Addendum #2

Project Name: Sandhills Publishing Project X - Phase II
100 W. Grand Dr, Lincoln, NE

Project No.: 14026

Issued: September 19, 2014

AD2 – L1 Sheet L200 revised details 04 and 05 pertaining to greenroof berm construction and roof drain shroud protection.

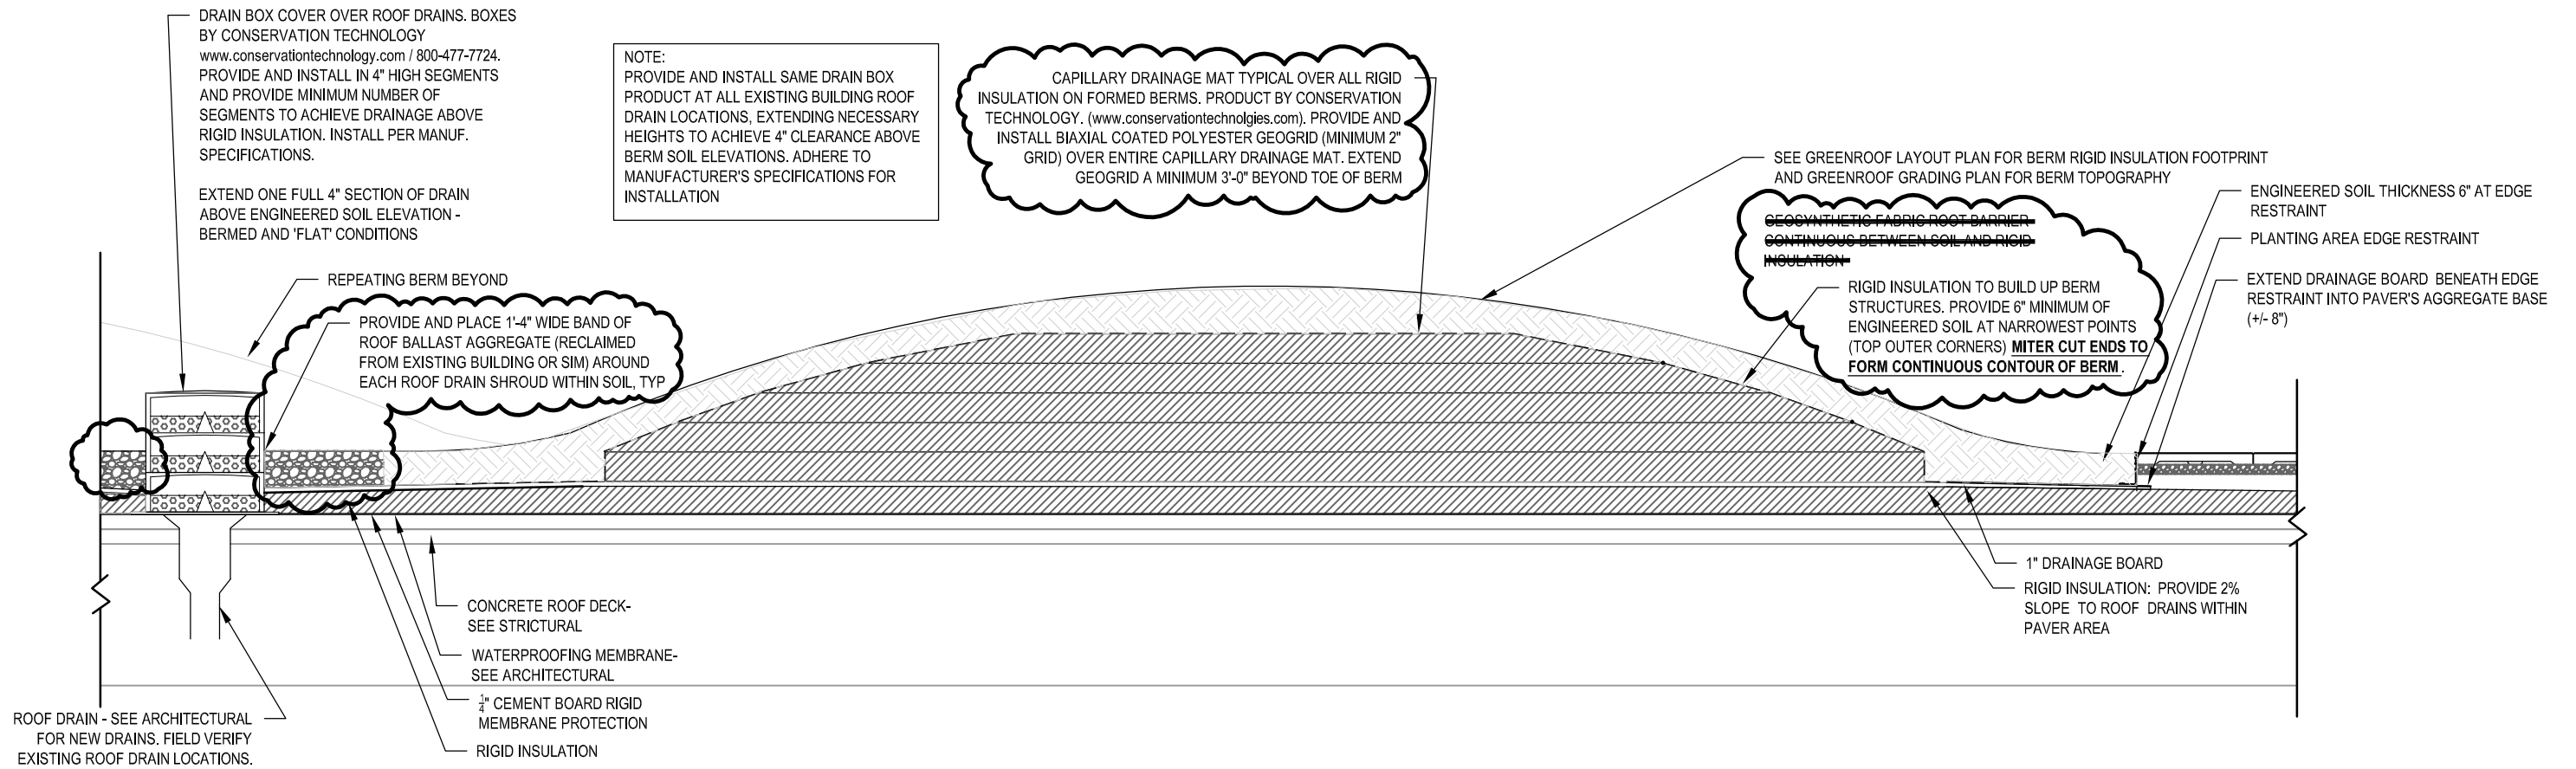
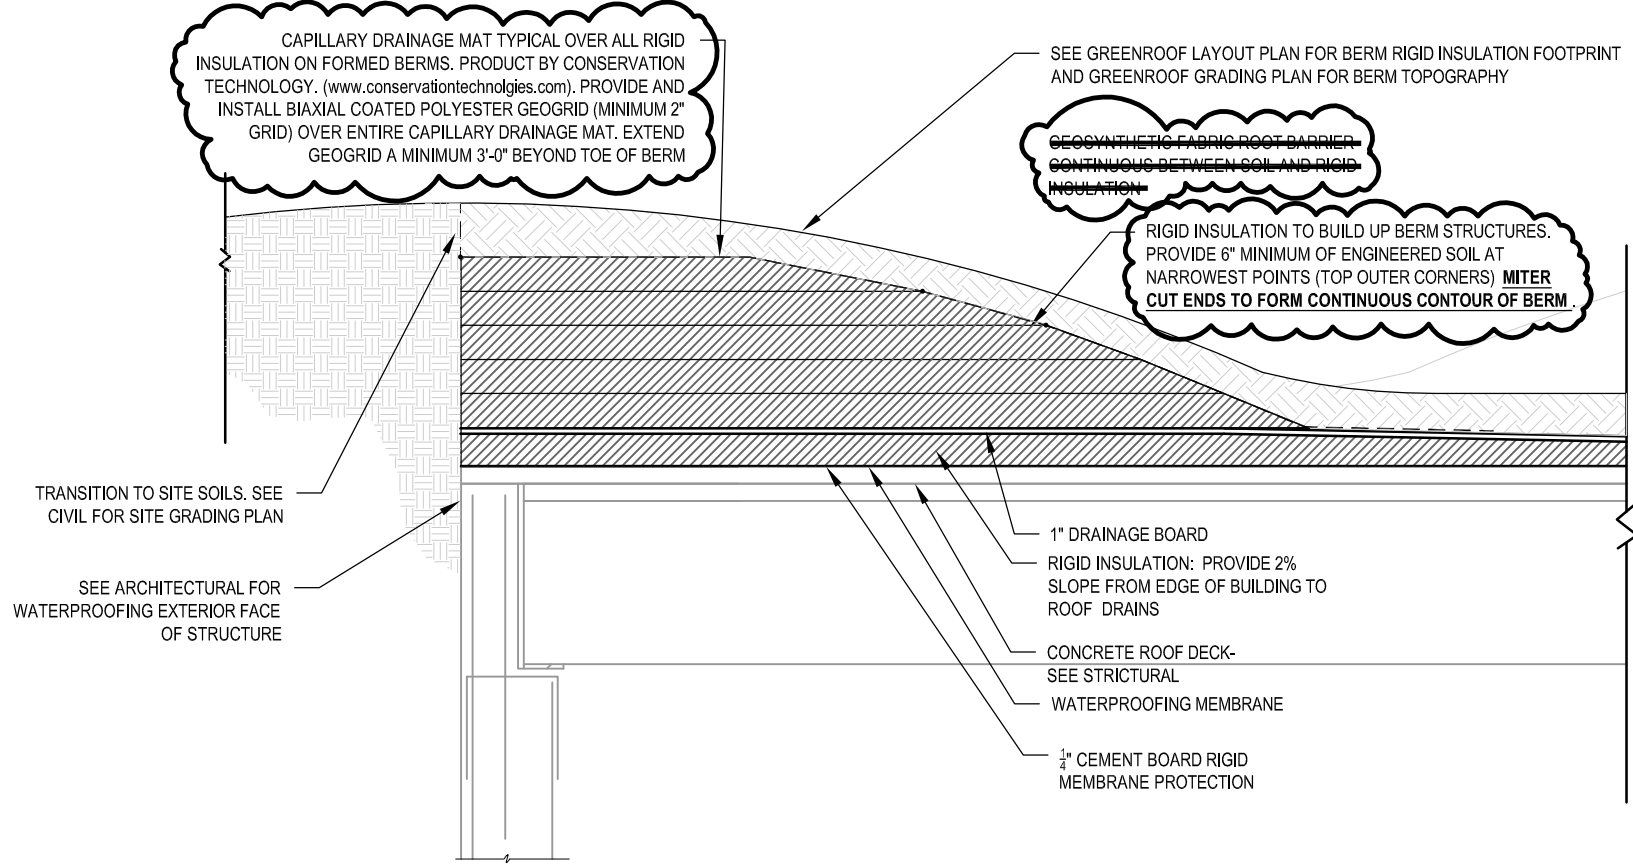
ADD 1-2. Sheet L200: Modify details 04 and 05 pertaining to greenroof berm section details. See attached exhibit L-1. Scope of modified work to include: (A) DELETE geosynthetic fabric root barrier over constructed berms, (B) ADD capillary drainage mat, as supplied by Conservation Technology, www.conservationtechnologies.com, continuous over berm rigid insulation, (C) ADD biaxial coated polyester geogrid (2" grid size minimum) and install over entire capillary drainage mat. Extend geogrid 3'-0" beyond toe of berm, and (D) ADD 1'-4" wide band of roof ballast (reclaimed from existing building's roof or similar) around every roof drain shroud located within soil areas of the greenroof.

ADS2-11 Structural section at walkway link.

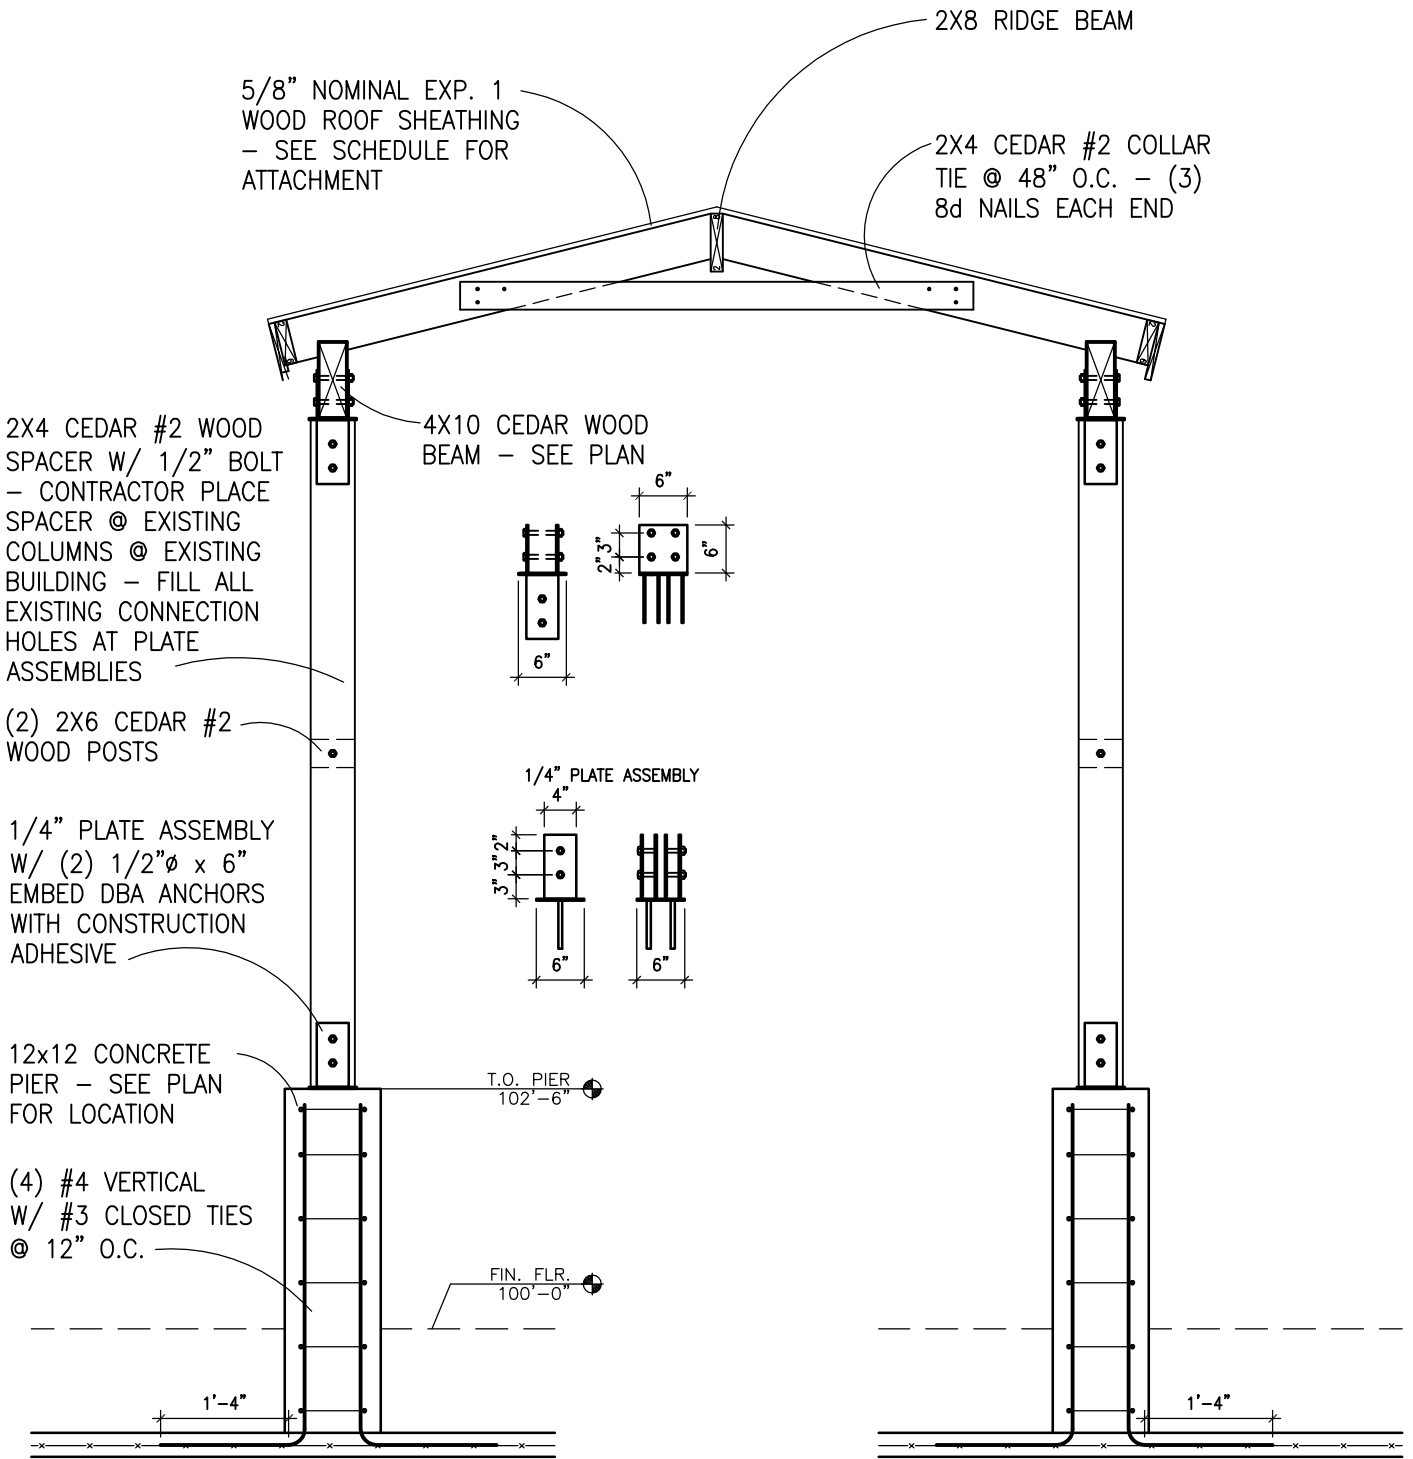
Q1: *The area between grid M.4 to A and grid 5 to existing building: What supports the 4x10 beams? Is there a connection to the existing building? Can a structural or architectural section be provided through this area?*

- ADD S2-5.** Add (6) #4 bars in the topping below the walkway columns over the twin tee garage members –Sheet S201.
- ADD S2-6.** Add (4) #4 bars X 8'-0" long under each pergola column – Sheet S201.
- ADD S2-7.** The east stair construction shall be wood. The lower level framing plan does not have the stair member callouts. The members shall match the upper level. The headers at the landings shall be (2) 1 ½"x9 ¼". Sheet S201
- ADD S2-8.** Slab on grade construction joints and control joints are shown – Sheet S201.
- ADD S2-9.** Please add detail ADS2-11 to the construction documents.

A1: Refer to Structural Items attached.
